Erratum

Figure 3.5: Program structure of the *phantom_control* node.

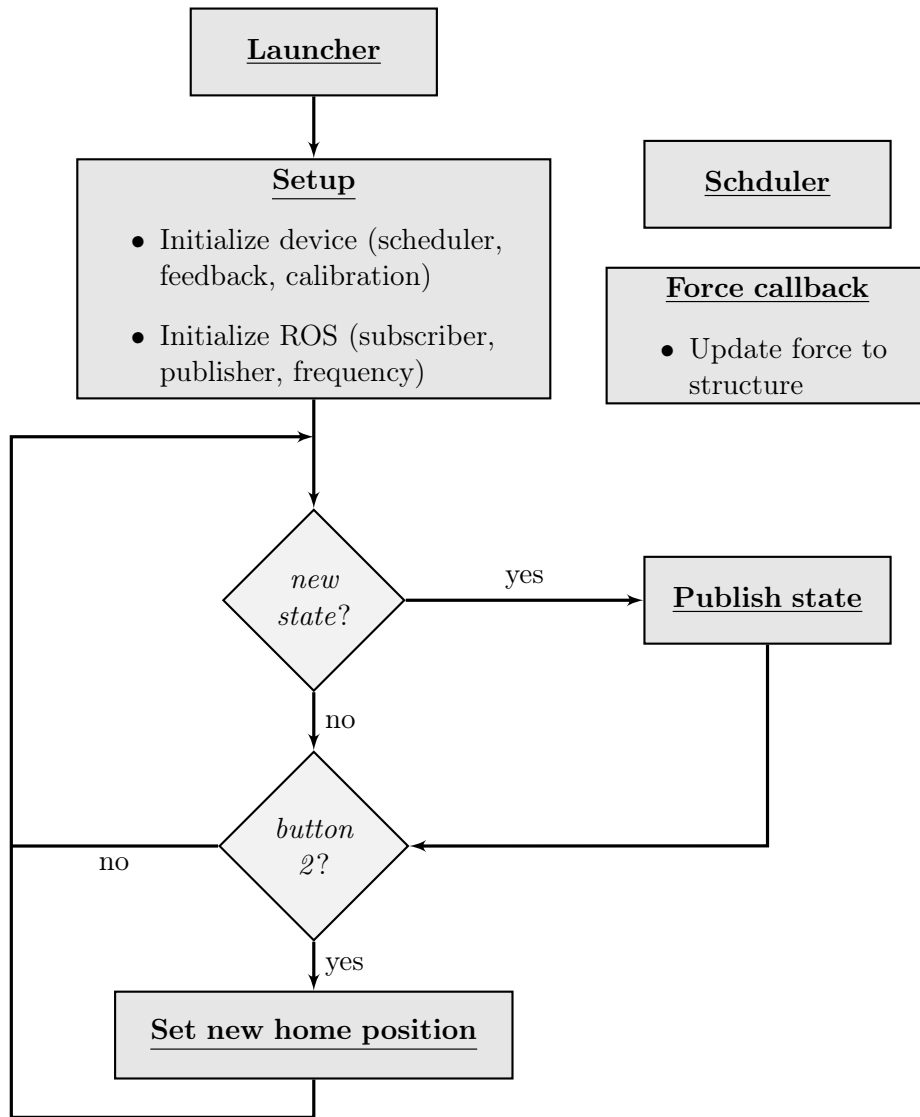
In Subsection 3.3, Module *haptic_force*, Figure 3.5 and it's legend are to be changed for the ones below.

Figure 4.2.1: Load cells arrangement for the demonstrations.

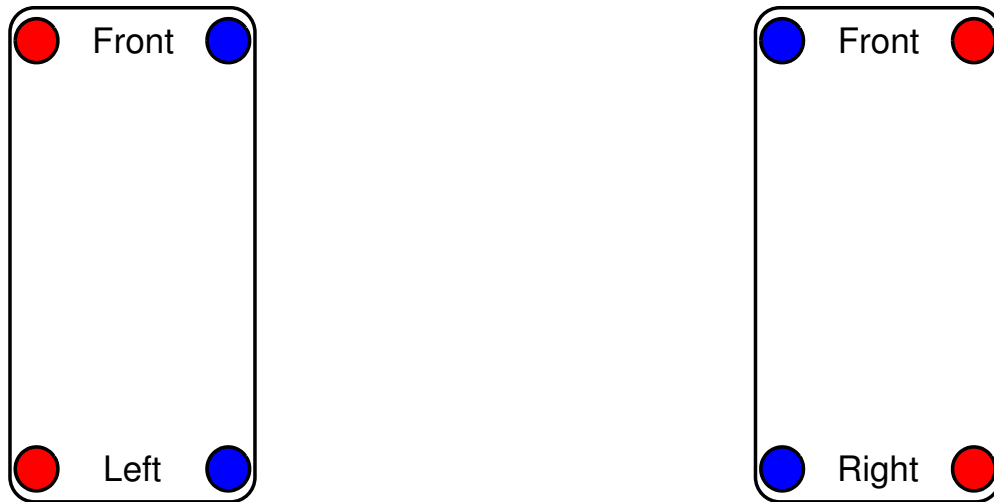
In Chapter 4, Robot's demonstrations, in the paragraph before Figure 4.2 there is a missing sentence. The following sentence is to be added at the end of the paragraph: *'In all of the demonstrations, the used arrangement of the load cells in the robot's feet is depicted in Figure 4.2.1 where the red cells correspond to the LSB-10 and the blue cells to the LBS-5.'*

After Figure 4.2, the Figure 4.2.1 is added as follows.
